TO: Mercedes-Benz Dealer Principals, General Managers, Sales Managers, Service Managers, Parts Managers	FROM: Anthony Washington, Department Manager, Regulations and Certifications
RE: Recall Campaign Notification Model 907 (Sprinter) Model Years 2019 Screw Connection Hood Latch	DATE: October 17, 2019

Campaign No. 2019100006, October 2019

SUBJECT: **Model 907 (Sprinter), Model Year 2019
Screw Connection Hood Catch**

D88.40-1130-06

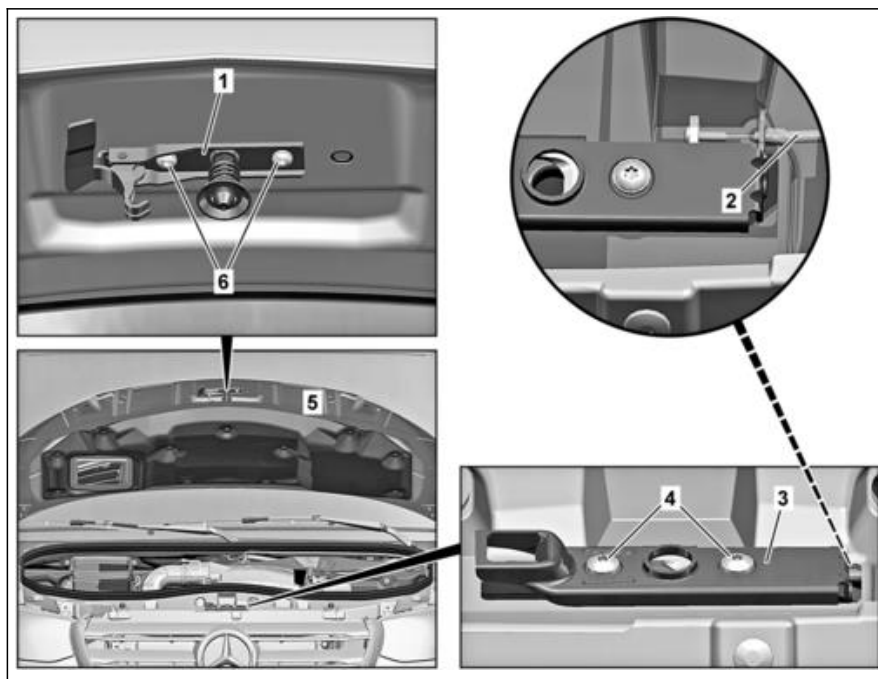
Daimler AG ("DAG"), the manufacturer of Mercedes-Benz Sprinter vans, has determined that, the screw connection on the upper hood catch of certain Mercedes-Benz Sprinter vehicles (VS30; Platforms 907) may not have been carried out according to specification. Depending on vehicle speed, wind resistance, aerodynamic drag and factors such as vehicle loading and road conditions, the hood could open while the vehicle is being operated. If the hood were to open while driving, it could impact the driver's field of vision, thereby increasing the risk of a crash. An authorized Mercedes-Benz Sprinter dealer will check and if necessary tighten the torque of the screw connection. Any missing screws will be replaced if necessary.

2	Check whether the screws (6) are present.	If a screw (6) are not present, ↓ screw in missing screw (6) subsequently by hand.	
Retighten Screws			
3	Retighten screws (6).	Bolt, upper section of hood catch to hood	BA88.40-N-1003-01TS

Number	Designation	Model 907
BA88.40-N-1003-01TS	Bolt, upper section of hood catch	8Nm
